**ADDENDUM No. 3**

Date September 02, 2014

Project Name Shoal Creek Greenbelt Trail Improvements

C.I.P. No. 6051.005

SHOAL CREEK GREENBELT - TRAIL IMPROVEMENTS  
 W. 5TH STREET TO W. 4TH STREET  
 WASTEWATER PLAN AND PROFILE  
 SHEET 1 OF 2

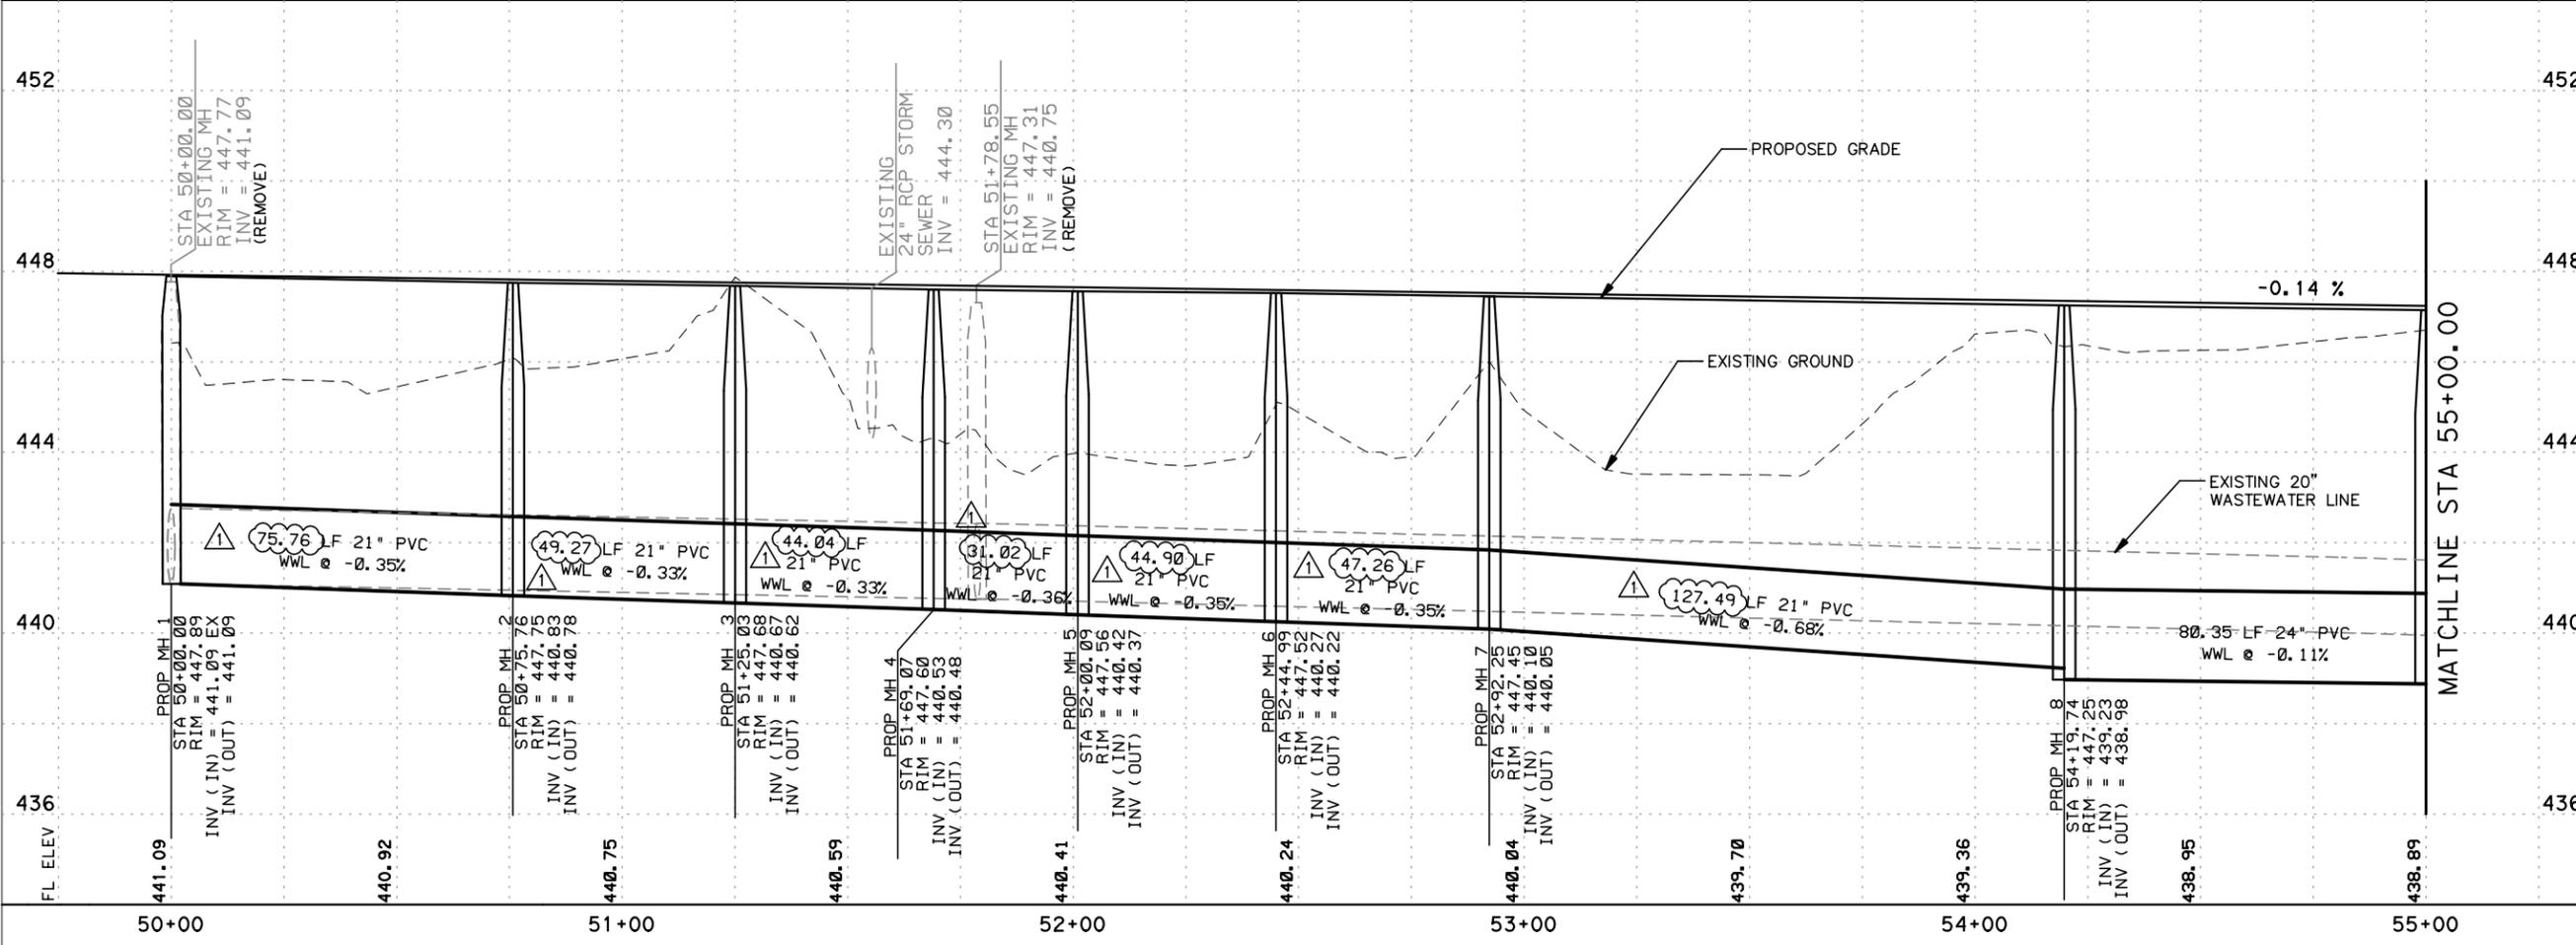
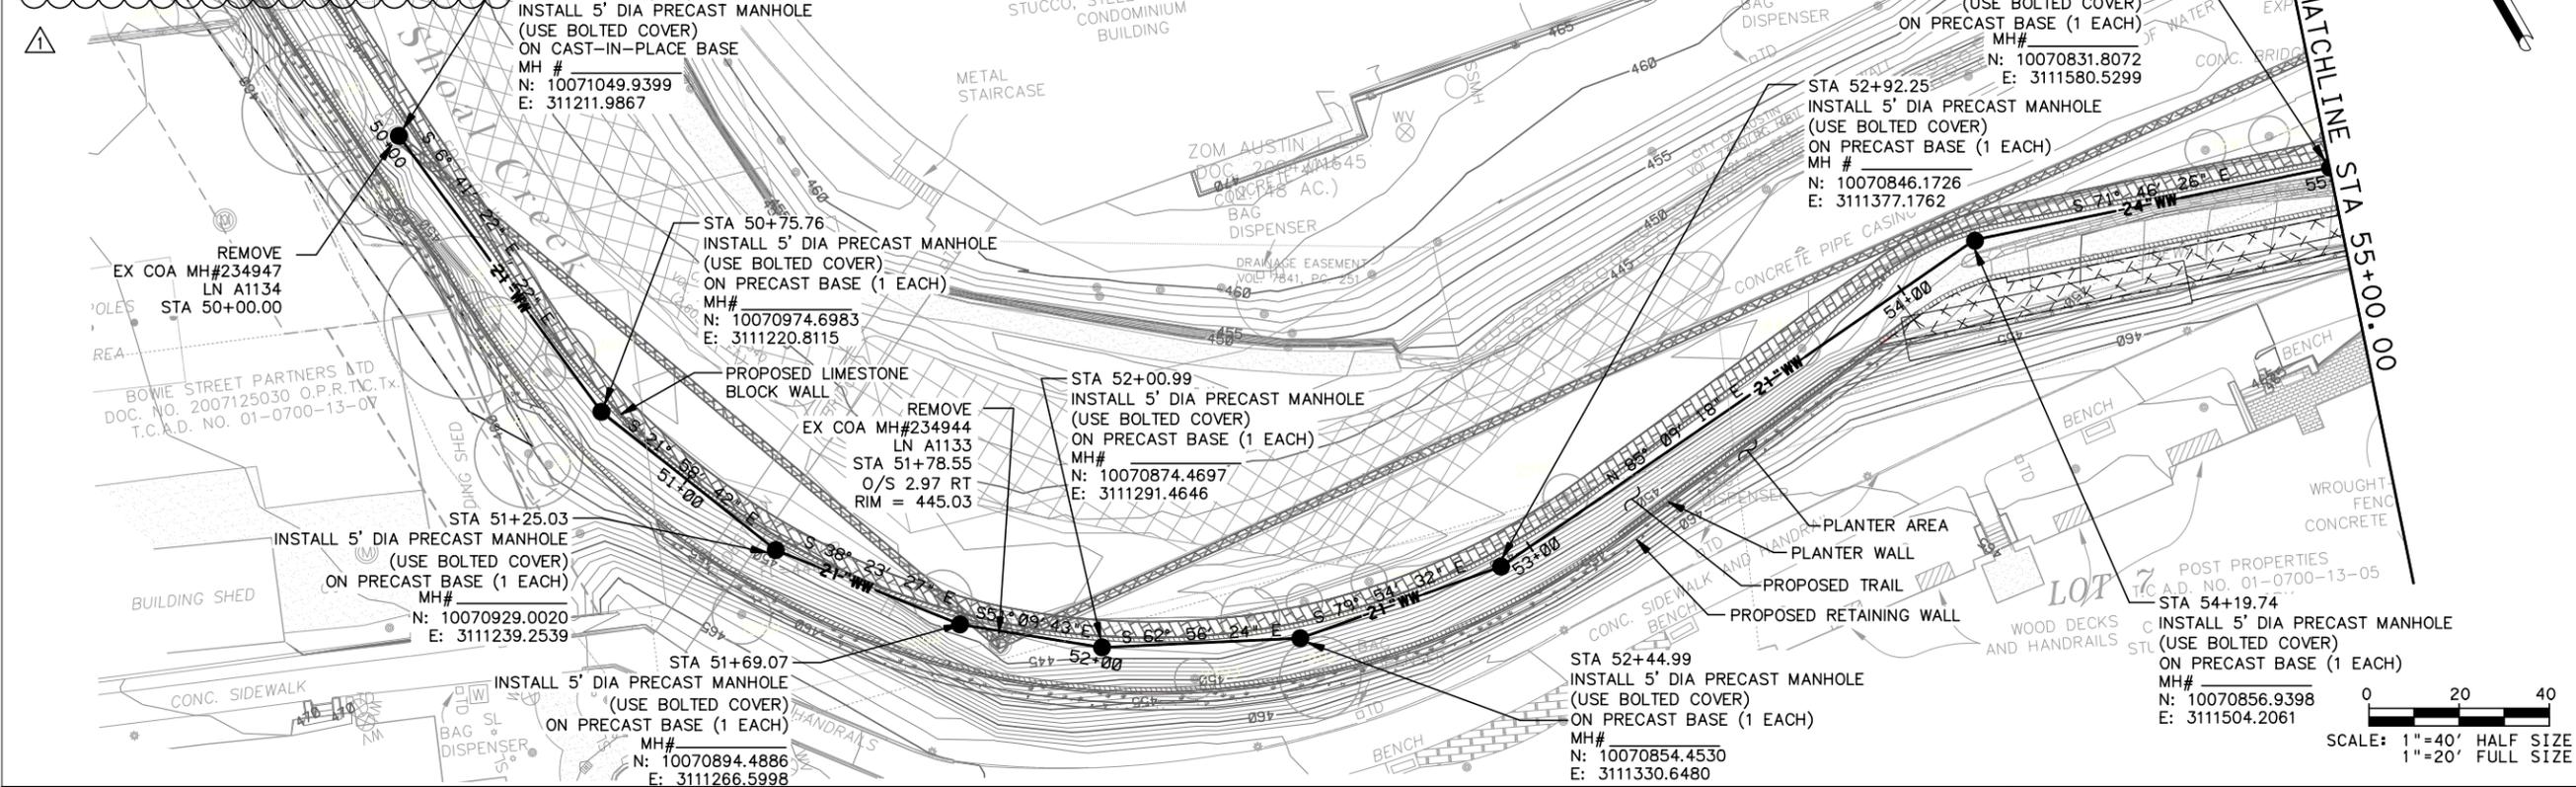
REV. NO.	DATE	REVISION DESCRIPTION
1	8/25/2014	ISSUED NOTES AND PIPE LENGTHS
